Petrotomics Company

Reference: Alternate Concentration Limits Application - Response to open issues 1, 4, and 5
- Source Material License SUA-551

PETROTOMICS TAILINGS FACILITY
APPLICATION FOR ALTERNATE
CONCENTRATION LIMITS
SOURCE MATERIAL LICENSE SUA 551
RESPONSE TO NRC OPEN ISSUES 1, 4, AND 5

RESPONSE TO NRC OPEN ISSUES 1, 4, AND 5

File: Figs5RLL.ppt

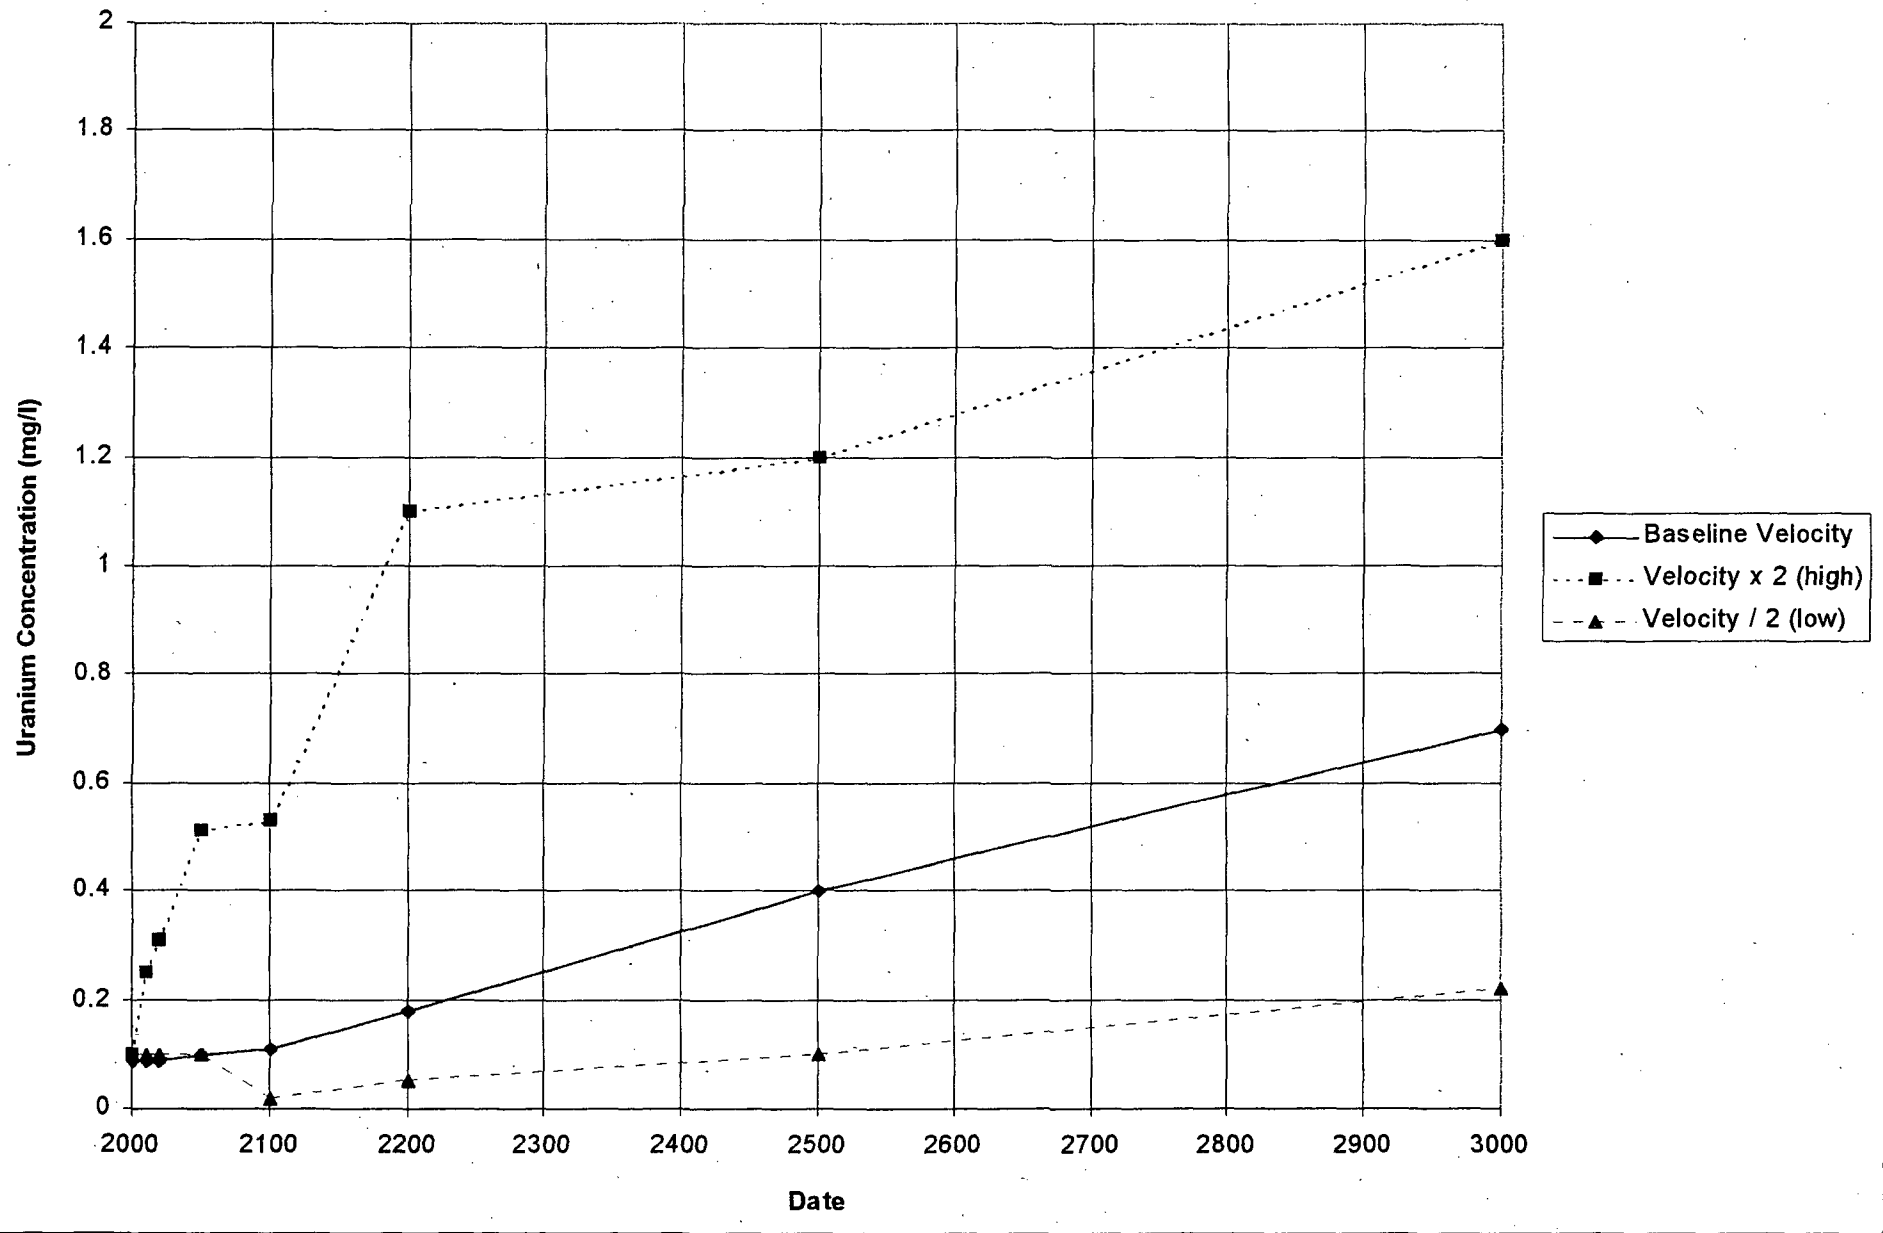
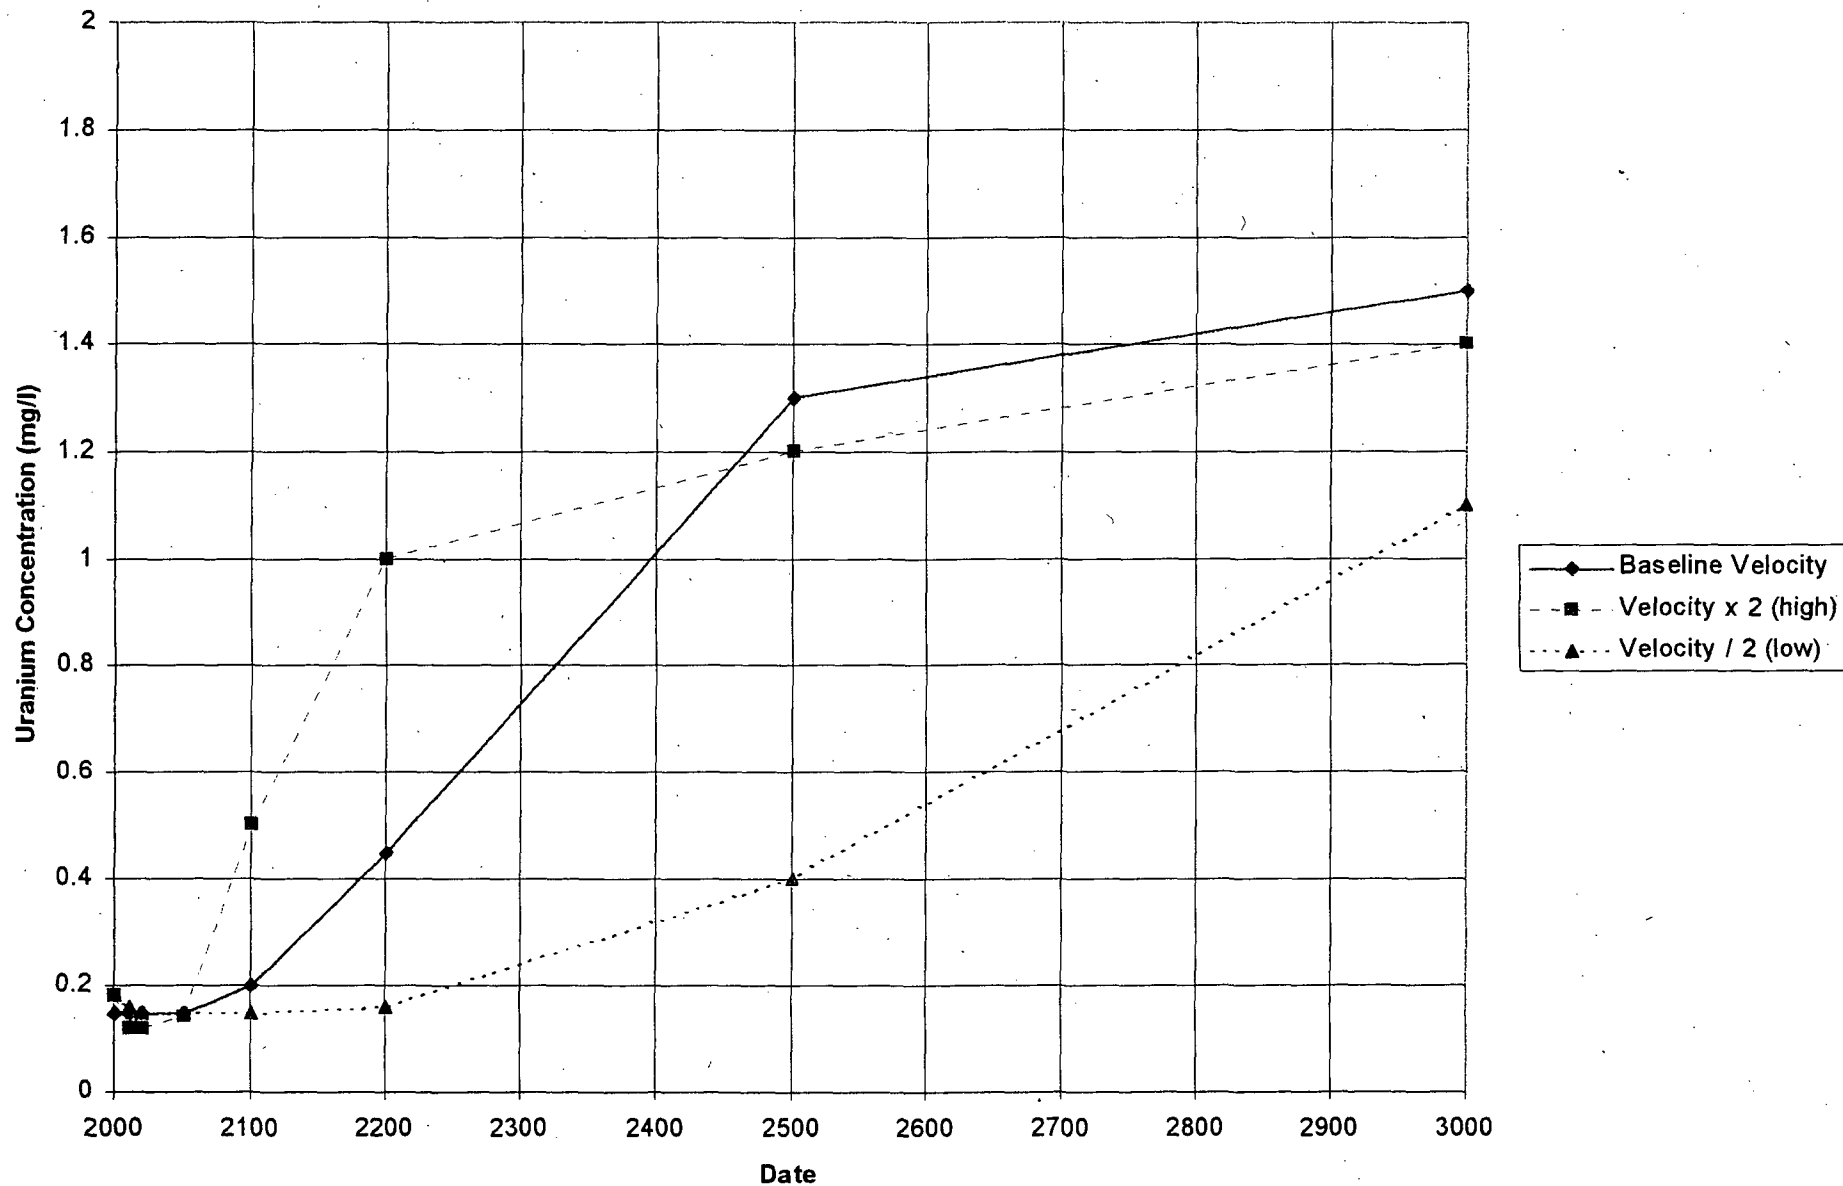
ACTION NEEDED: Petrotomics should provide a quantitative verification that the calibrated model can predict the potentiometric contours of the site in 1996 with reasonable accuracy when initialized in 1985. The conservativeness of the modeling can be proved by showing quantitatively that during the 10-year period of 1986-1996 the model overpredicts the migration of contaminants. If the model predictions are not within the acceptable range, Petrotomics should perform sensitivity analysis to show the conservativeness of the model so that it can be successfully used for conservative predictive modeling for [the] next 1000 [years]. Additionally, Petrotomics should provide a working copy of input files for MODFLOW, basis for hydraulic conductivity values, and its distribution map, and calibrated input parameters.

The sensitivity of model predictions to higher and lower ground water velocity was simulated. The baseline MODFLOW velocity files used by the RAND3D transport model were modified as part of the sensitivity analysis. Baseline velocity files included ground water velocity distributions for the years 1995, 2000, 2010, 2020, 2050, and steady-state. Ground water velocities were adjusted uniformly by a factor of two (100 percent increase in ground water velocity) for the high velocity scenario, and decreased uniformly by a factor of two (50 percent decrease in velocity) for the low velocity scenario. This range of ground water velocity is considered highly conservative, and should adequately account for uncertainties in flow model parameter values. Results of the modified transport model were then compared to the baseline predictions presented in Petrotomics (1996).
